Council of the City of York, PA
Session 2019
Resolution No. 43

Council hereby **denies** a Certificate of Appropriateness as recommended by the Historical Architectural Review Board for work to be completed as submitted in the following application:

Resolution No. 43 of 2019
Asbury United Methodist Church
340 E. Market St.
York, PA

**York Historical Architectural Review Board
Meeting Minutes
May 23, 2019**

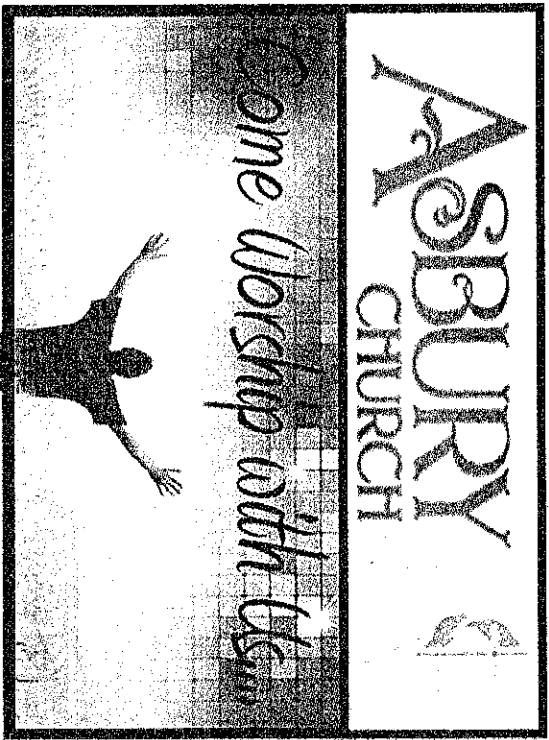
Discussion: The applicant distributed photographs of the church and the proposed sign. The proposed sign is a traditional lightbox on the top half and a digital display on the lower half. The digital sign will be used for public outreach and to disseminate information to the community about church functions. The display would be equipped with emergency alert capabilities and could be dimmed depending on ambient conditions.

Mr. Skehan explained that the proposed sign is not appropriate for the historic district, as digital and internally illuminated box signs were never used historically. He pointed out that the historic district guidelines specifically discourage internally illuminated signs. He explained that any existing illuminated signs within the district, with few exceptions, were installed without prior approval. He explained that backlit signs and indirectly illuminated signs are considered appropriate, and that the illuminated sign on the Strand Theater was approved because theaters have a historic tradition of using illuminated signage beginning in the early 20th century.

Ms. Robbins stated that the existing sign could be moved or turned and illuminated indirectly to increase its visibility. Mr. Skehan and Mr. Redshaw discussed options for moving the existing sign. The applicants stated that investing in moving the sign wouldn’t have a big enough pay off to justify the cost. They indicated their concern that static signs “are not seen.”

Mr. Shermeyer stated that while the digital sign would not be approved by the Board, he encouraged the applicant to work toward a compromise. He suggested that perhaps a more modern sign with raised letters, rather than a lightbox, which could be set within the stone surround of the existing sign. The applicants restated their desire for a digital display and internally illuminated sign, as proposed.

Motion: Mr. Redshaw motioned to deny the application as presented, because digital and internally illuminated signs are not appropriate to the character of the church or the surrounding district, and Ms. Robbins seconded.

Vote: 4-1. The motion to deny the application passed with Mr. Shermeyer abstaining because he would have liked to have seen a compromise.
